**Subject: MHI's 3rd Amended Response to US-APWR DCD RAI No. 740-5719
Revision 2 (SRP 06.02.02)**

3rd Amended Response to Request for Additional Information
No. 740-5719 Revision 2

RAI NO.: NO. 740-5719 REVISION 2
SRP SECTION: 06.02.02 – Containment Heat Removal System
APPLICATION SECTION: 6.2
DATE OF RAI ISSUE: 4/26/2011

QUESTION NO.: 06.02.02-64

Figure b-1 Film Condensation on Structure Surface

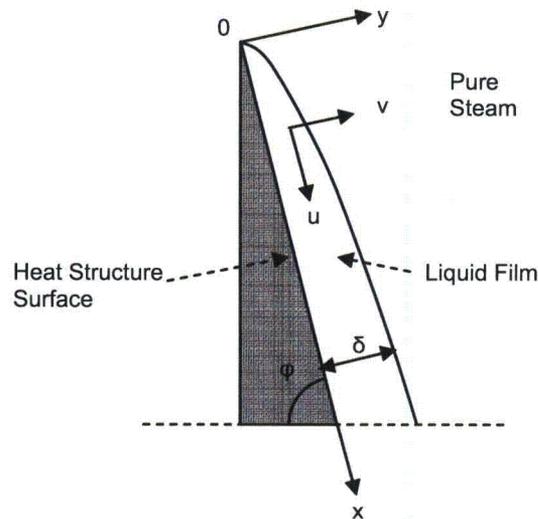
- o Condensate water on containment surfaces – Equation listed for film condensation correlation used to calculate film thickness could not be readily verified (reference in Japanese) and was not found in standard textbooks on heat and mass transfer. Appropriate reference and justification should be provided for the applied methodology and selected input values. Film thickness will be a function of the surface height. Justify estimated vertical surface area and corresponding heights used in the calculations.

Condensate film thickness was calculated from Eq. 11 in the hold-up volume calculation based on the fluid conditions. The calculation follows the methodology of theoretically solving the Nusselt film heat transfer correlation, which is widely known (References 4 and 5).

Assume constant condensation and liquid flow on structure surfaces (Figure b-1).

Condensation liquid thickness on the surface of the heat structure is predicted by Eq. 11. The height used for this calculation was 40 meters (about 130 feet), and the resulting condensation film thickness (based on 40 meters height) was applied to all surfaces. The vertical portion of containment from the second floor level (EL 25'-3") is about 129 feet. If the vertical height (x) increases, the liquid film thickness also increases as shown in Eq. 11. However, the liquid thickness calculated based on a 40 meter height was conservatively applied to all surfaces.
